### **Planning and Regulatory Committee**

Wednesday 26 July 2023, 10.00 am

## **Schedule of Committee Updates/Additional Representations**

**222314 - ERECTION OF A FREESTANDING RESTAURANT WITH DRIVE-THRU FACILITY, CAR PARKING, LANDSCAPING AND ASSOCIATED WORKS, INCLUDING CUSTOMER ORDER DISPLAYS (COD), GOAL POST HEIGHT RESTRICTOR, PLAY FRAME AND PUMPING STATION.**

**Picture 9 – Diagram showing corrected headlight glare projections**

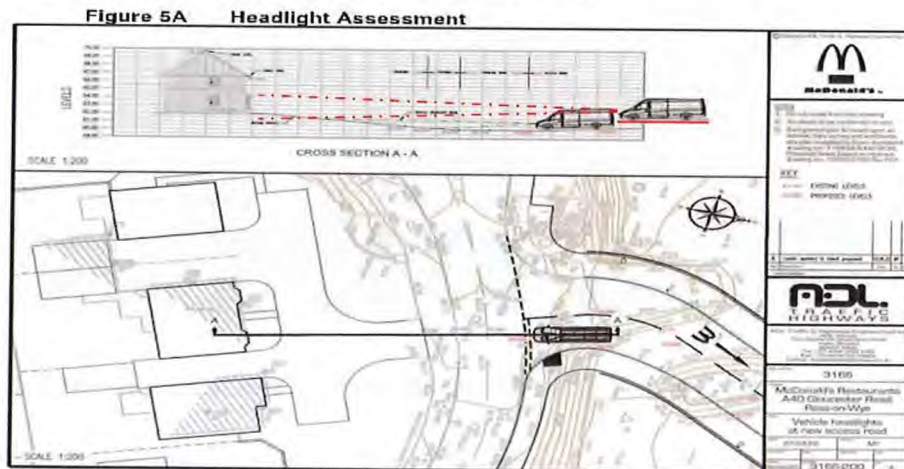
In response to our previous concern on headlight glare directly into the residential properties on Starling Road, McDonald's has made a poor attempt at demonstrating they have resolved the issue. The truth is that whilst reducing the opening hours from 24hrs to 0600-0000 does reduce the impact somewhat, there is still a significant amount of 'after dark' time within the revised opening hours.

The second part to which McDonald's again try to mislead the reader is by the diagram used to show the modelling of headlight glare. Figure A Headlight Assessment.

What that picture failed to show is if you were to move the vehicle back towards the Drive-Thru by just one car length, the headlight glare would be directly into the garden, ground and first floor of the residential property (See corrected picture above). This is because the land to which this application relates to, is raised in height from the point it joins Starling Road thus raising the height of the headlight beam.

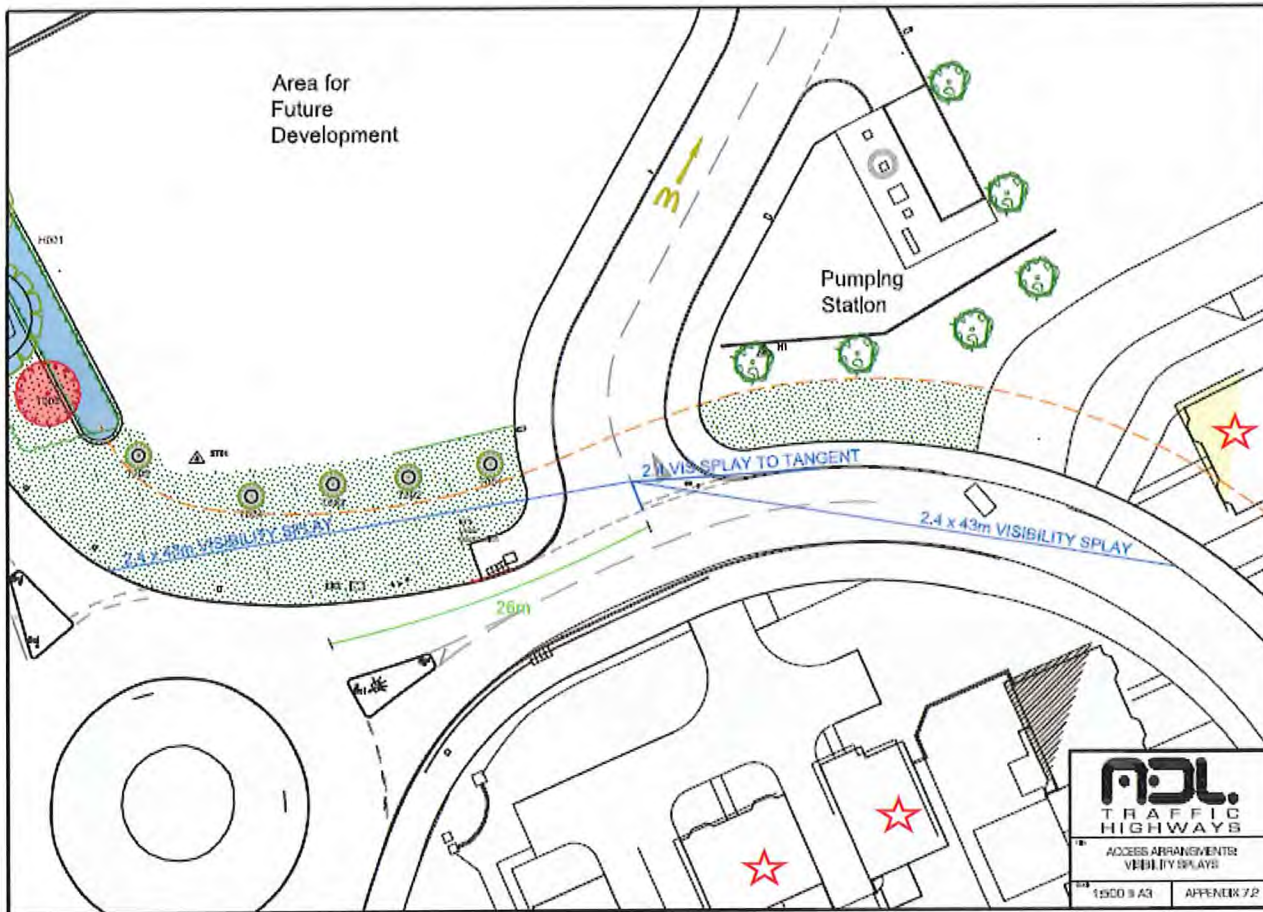
Any passenger in a vehicle queuing on Starling Road (in the area indicated by the green line on this drawing) would be able to see **directly into the front gardens, ground and first floor of the properties marked with a red star**. This would be particularly apparent at night time. Properties further round Starling Road would have pedestrians loitering to eat their takeaways off site, as there is a private communal area and play area less than 100m along the road. This is a totally unacceptable invasion of the right to privacy. **SD1, 5.3.30 requires designs to take account of “overlooking” this is in regards to both customers on site and increased pedestrians loitering to eat their takeaways off site.**

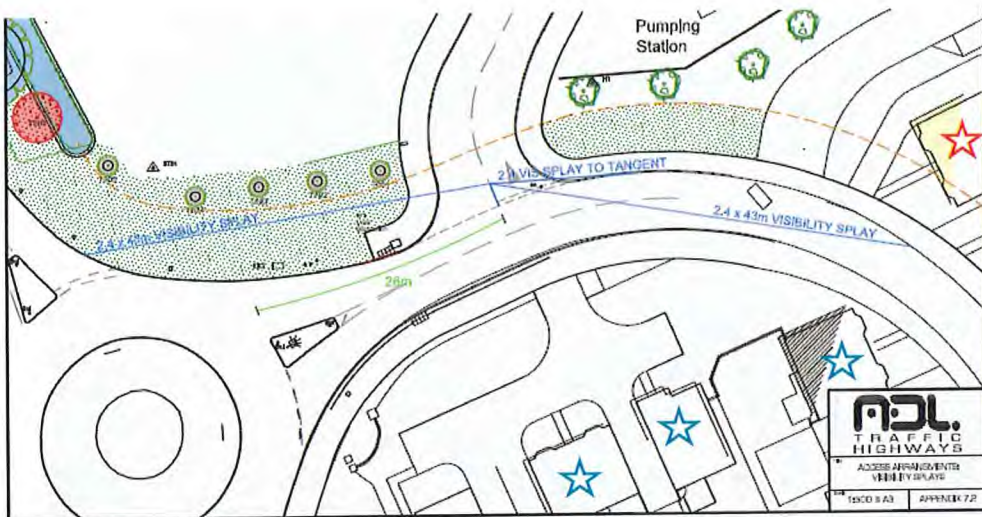
As shown in the following section of the plan drawing, the pumping station for the restaurant would be within 25m of a residential property. No data has been shared about the noise or odour pollution from this station, particularly at such close range, which directly impacts on this property.

The noise, pollution and privacy nuisance to this property in respect of the exit lane from the Drive-Thru and car park have also not been considered in the application. The proximity of this station to a residential dwelling must be considered under Core Strategy Policy SD1.
